# BEFORE THE MERIDIAN CITY COUNCIL

IN THE MATTER OF THE )	
REQUEST FOR FINAL PLAT	
CONSISTING OF 17 BUILDABLE )	CASE NO. FP-2025-0009
LOTS ON 34.04 ACRES OF LAND	
IN THE C-G ZONING DISTRICT )	ORDER OF CONDITIONAL
FOR DISTRICT AT TEN MILE )	APPROVAL OF FINAL PLAT
SUBDIVISION NO. 1	
BY: KIMLEY-HORN )	
APPLICANT )	
)

# STAFF REPORT

SUBJECT: FP-2025-0009

# B. Final Plat (dated: 8/13/25)

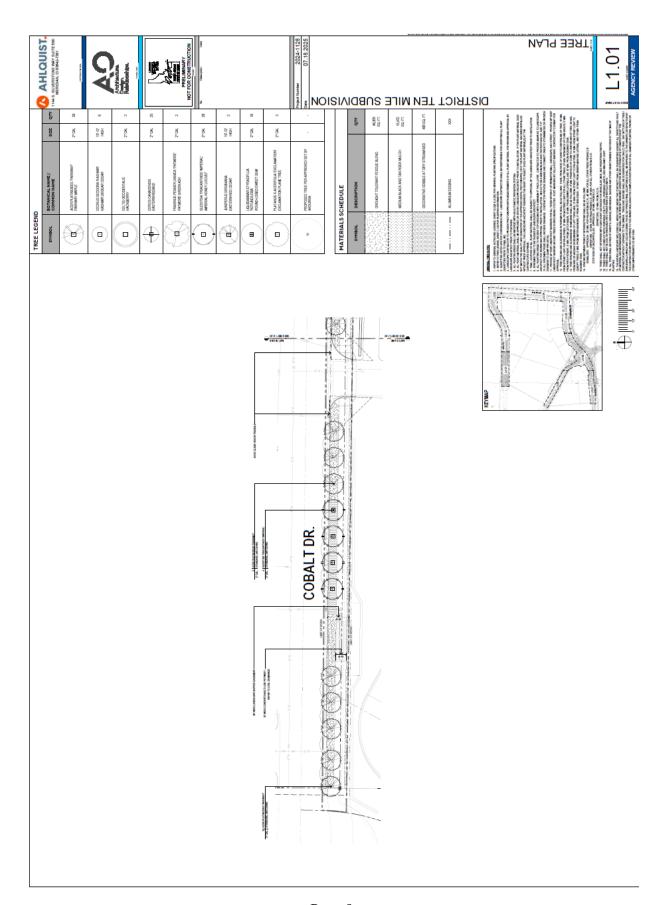
- 3. Prior to submittal for the City Engineer's signature, have the Certificate of Owners and the accompanying acknowledgement signed and notarized.
- 4. The final plat prepared by Kimley-Horn, stamped on 8/13/25 by W. Travis Bradley, included in Exhibit B shall be revised as follows:

- a. Under Notes section on Sheet 4:
    - i. Note #3: Delete note in favor of note #5.
    - ii. Note #4: Include the recorded instrument of the CC&R's.

- iii. Note #5: Include the recorded instrument number of the development agreement (i.e. #2023-022884).
    - iv. Note #7: Complete missing information.

- v. Note #11: Include the ACHD temporary license agreement instrument number.
    - vi. Note #12: Complete the missing information.
    - vii. Note #13: Complete the missing information.

- viii. Note #14: Complete the missing information.
    - ix. Note #15: Complete the missing information.
    - x. Include a note stating who the responsible party is for maintenance of the street buffer landscaping along N. Ten Mile Rd., W. Cobalt Dr. and W. Grand Mogul Dr. (i.e. the property owner or business owner's association) in accord with UDC 11-3B-7C.2a.

- b. Include the phase number (i.e. No. 1) in the subdivision name.
  - c. Under the Surveyor's Narrative on Sheet 5, include the missing information in Note #2.

- d. Include the recorded instrument number of the public water and sewer easement graphically depicted on Sheets 2 and 3.
  - e. Depict 10-foot-wide detached sidewalks/pathways on the construction plans in the street buffers along N. Ten Mile Rd. and W. Grand Mogul in the areas where 6-foot-wide walkways are currently depicted near the intersections of Grand Mogul/Ten Mile and Cobalt/Ten Mile unless a physical barrier exists that prevents compliance. Submit a copy of the updated construction plans with the application for final plat signature.

- f. Widen the 5' wide parkways depicted west of first driveway off Grand Mogul to 8' consistent with Street Sections B & C in the TMISAP on the construction drawings.

- g. Include the recorded instrument number(s) for the multi-use pathway public use easement.
- 5. The landscape plan prepared by AO Architects, dated 7/18/25 included in Exhibit C, shall be revised as follows:

# C. Landscape Plan (dated: 7/18/25)

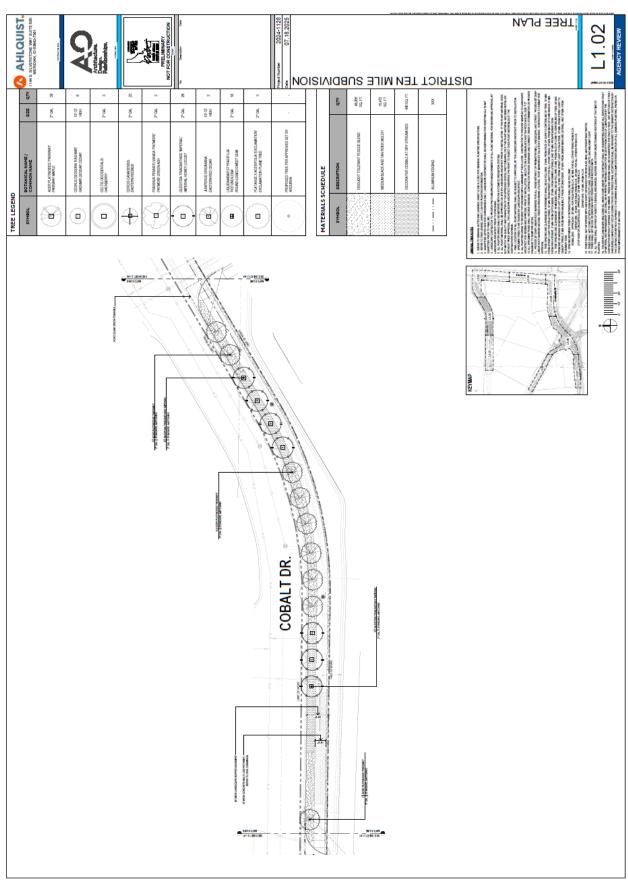
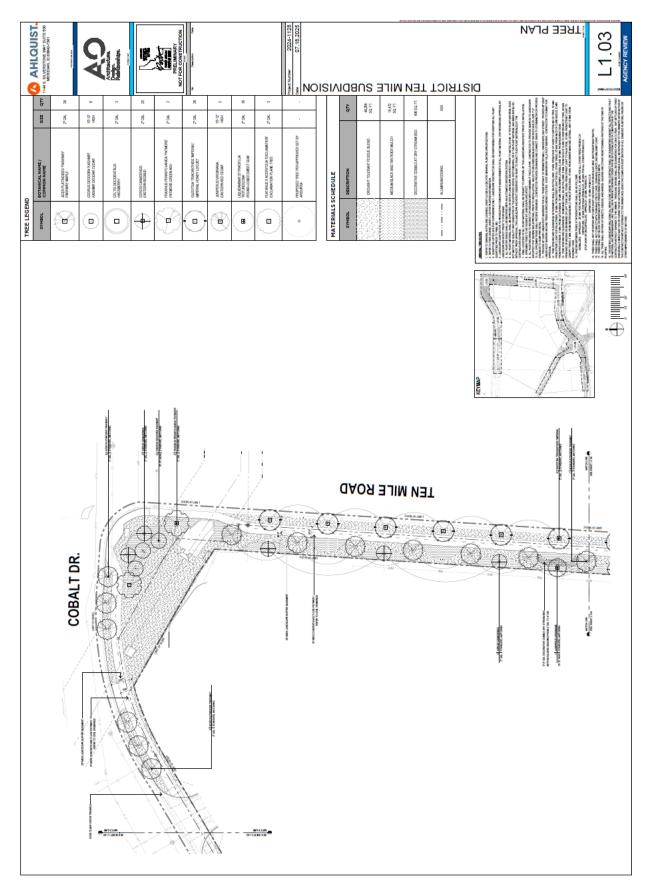
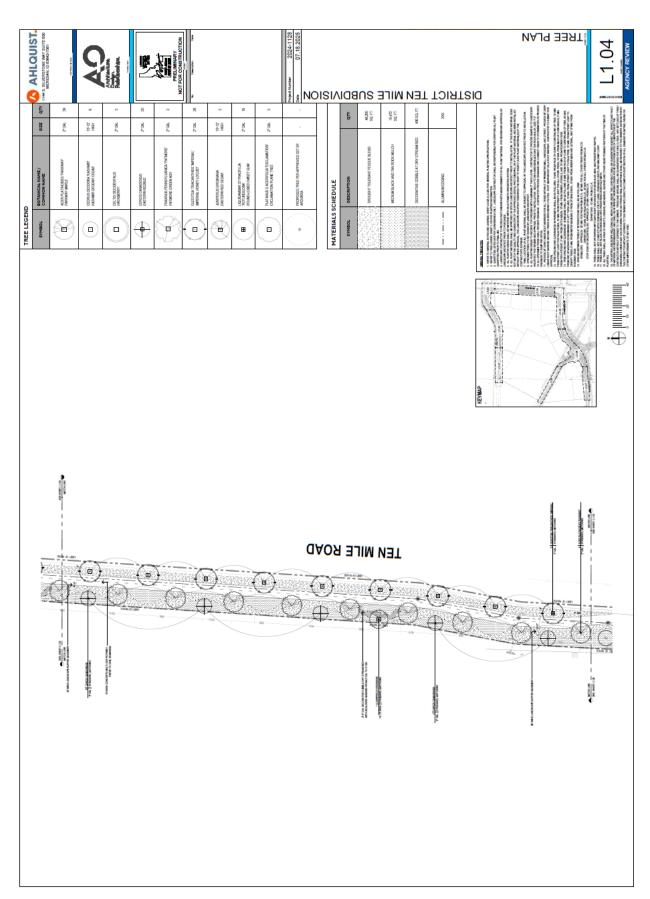
- a. Depict 10-foot-wide detached sidewalks/pathways in the street buffers along N. Ten Mile Rd. and W. Grand Mogul in the areas where 6-foot-wide walkways are currently depicted near the intersections of Grand Mogul/Ten Mile and Cobalt/Ten Mile unless a physical barrier exists that prevents compliance.

- b. Depict landscaping within the street buffer along W. Grand Mogul Dr. in accord with the standards listed in UDC 11-3B-7C.3 (i.e. depict a variety of shrubs and vegetative groundcover along with the 37 trees that elicit design principles including rhythm, repetition, balance and focal elements). Also revise the Project Calculations table on Sheet L1.00 to reflect a total of 37 street trees are proposed in the buffer.

- c. Depict landscaping along the multi-use pathway adjacent to the Purdam Drain in accord with the standards listed in UDC 11-3B- 12C (i.e. 5-foot-wide landscape strips are required along each side of the pathway planted with a mix of trees, shrubs, lawn, and/or other vegetative groundcover a minimum of one tree per 100 linear feet of pathway is required include calculations in the Project Calculations table that demonstrate compliance).

- d. Widen the 5' wide parkways depicted west of first driveway off Grand Mogul to 8' consistent with Street Sections B & C in the TMISAP.
- 6. A Certificate of Zoning Compliance application shall be submitted and approved for all development on the site prior to submitting any associated building permit applications.
